REVISED RESPONSE TO REQUEST FOR ADDITIONAL INFORMATION

APR1400 Design Certification

Docket No. 52-046

RAI No.: 553-9084
SRP Section: 18 – Human Factors Engineering
Application Section:
Date of RAI Issue: 09/06/2017

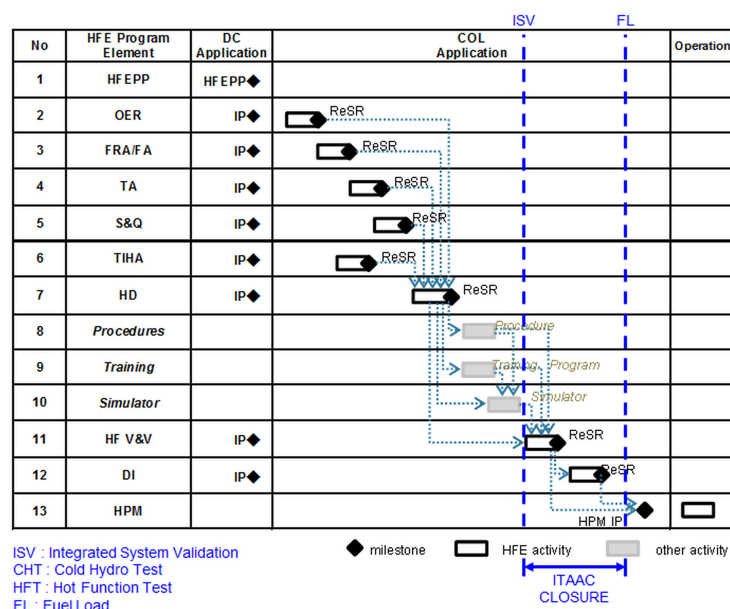
- a. Either (1) expand the scope of ITAAC Item 1 in Table 2.9-1 to include the other HFE activities that have associated implementation plans as well as the other V&V activities, or (2) add additional ITAAC to Table 2.9-1 for each HFE activity that has an associated implementation plan. DCD Tier 2, Section 14.3.2.9, “ITAAC for Human Factors Engineering,” and Section 14.3.5, “Design ITAAC Closure Process,” should be revised if DCD Tier 1, Section 2.9, “Human Factors Engineering,” is revised.

- b. Explain why the sections of the HFE IPs and the scenarios document listed above are not Tier 1 given they contain DAC that will be acceptance criteria for ITAAC.

- c. If the sections listed above of the HFE implementation plans and scenarios document will be Tier 1, then delete the HFE implementation plans from DCD Tier 2, Table 1.6-2, and include the sections listed above of the HFE implementation plans and the scenarios document in the DCD Tier 1. If KHNP proposes to make the sections listed above of the HFE implementation plans and the scenarios document Tier 2* instead of

Tier 1, then add the scenarios document to DCD Tier 2, Table 1.6-2, and uniquely identify proposed Tier 2* information in the application (e.g., with brackets and italics).
